Subj: BRANCH MEDICAL/DENTAL CLINIC, QUANTICO POE REPORT

POST OCCUPANCY EVALUATION REPORT

BRANCH MEDICAL/DENTAL CLINIC QUANTICO, VIRGINIA

PREPARED BY: NAVFACHQ MEDICAL FACILITIES DESIGN OFFICE

Picture 12

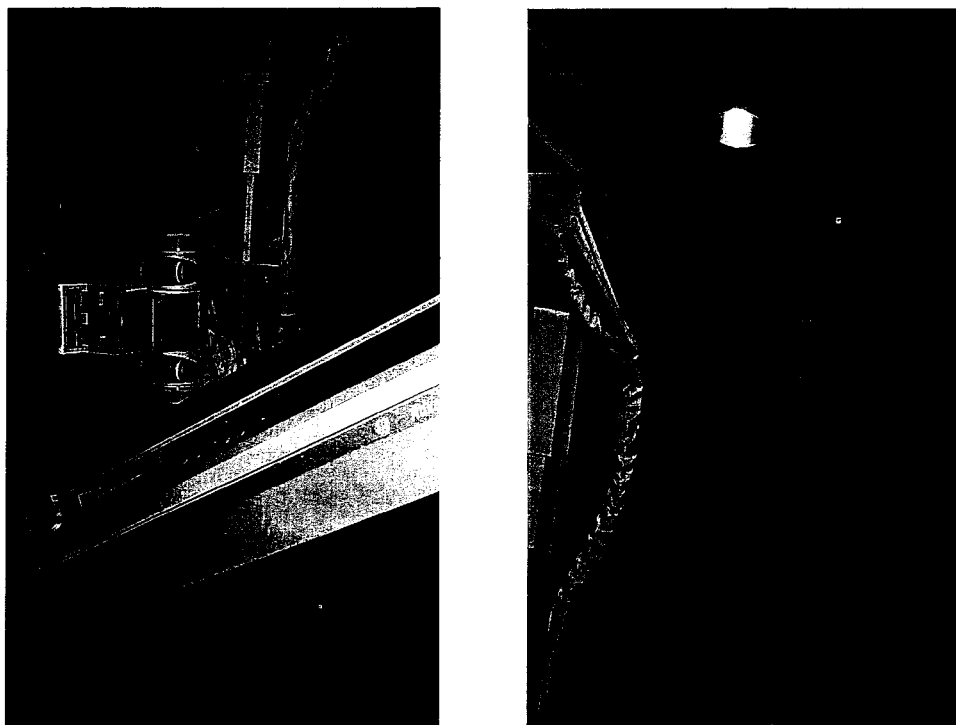
42. Table and chest-bucky too close. Tube head hits table; cannot get as low as desired for child. Therefore, child has to be placed on stool. Recommend that switch/breaker for power be placed in "protected area" behind control wall. Techs need training from installer on exactly how room functions regarding x-ray equipment. X-ray rooms look very nice; wires/cables/ industrial looking equipment well concealed. Appear to satisfy function. *Radiology, Rad Room*
1G07 - Gold Team

Picture 17

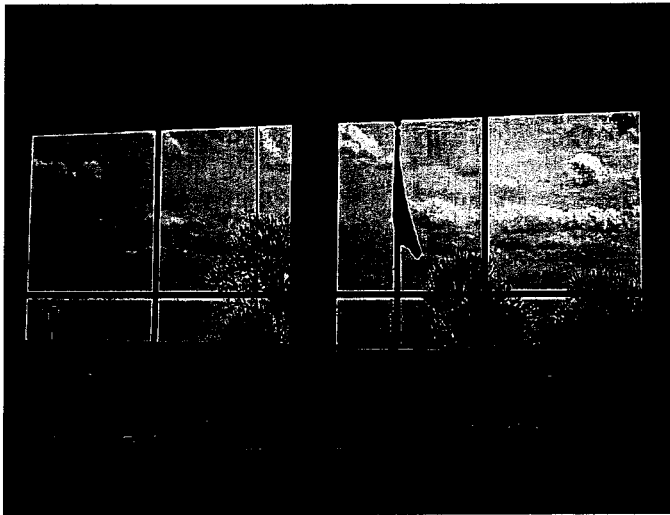
9. Who specified or accepted the flagpole? It is not the type the user desired. *Exterior, Flag Pole - Blue Team*

Picture 19

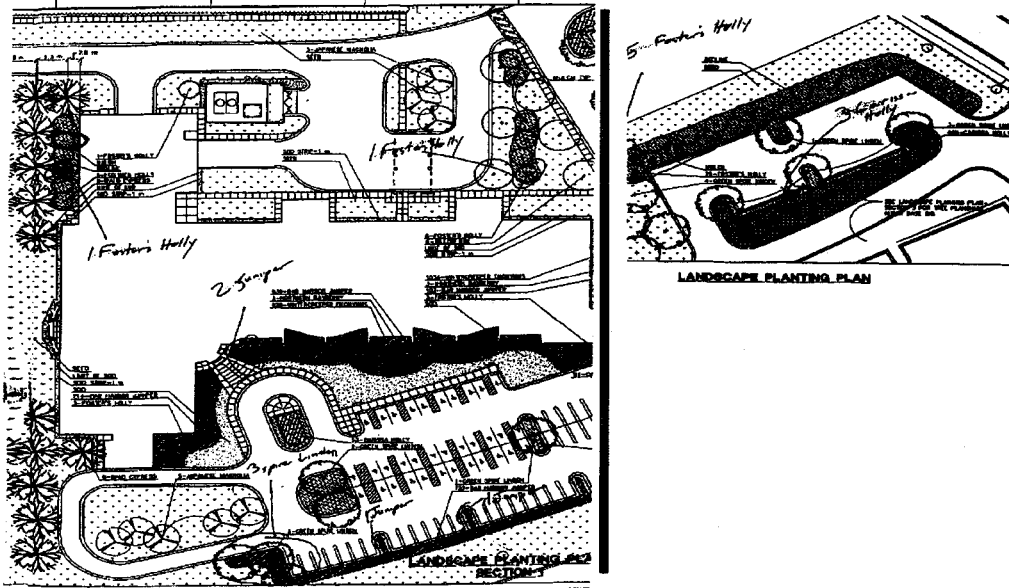
13. Attached is a drawing showing the location of plants and trees that have died and need to be replaced. *Exterior, Landscaping - Blue Team*

Picture27

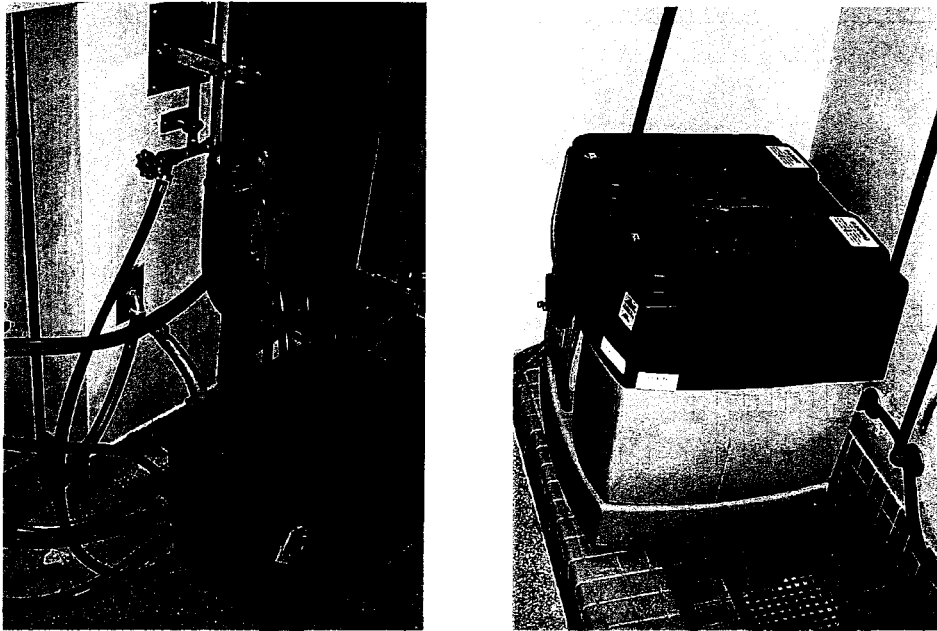
71. Counter top that supports the developer (AT-2000) should be deep enough to allow the equipment to sit correctly on the surface facing the user. Per agreement between dental and medical, medical processes the waste from the processor and therefore there is no silver recovery unit here. *Dental, Darkroom 2A23 - Blue Team*
72. Mop basin not sufficiently sized for mixing units; also no room to place silver recovery in mop basin. User would like to place basin below silver recovery unit. *Radiology, Darkroom 1F01 - Gold Team*
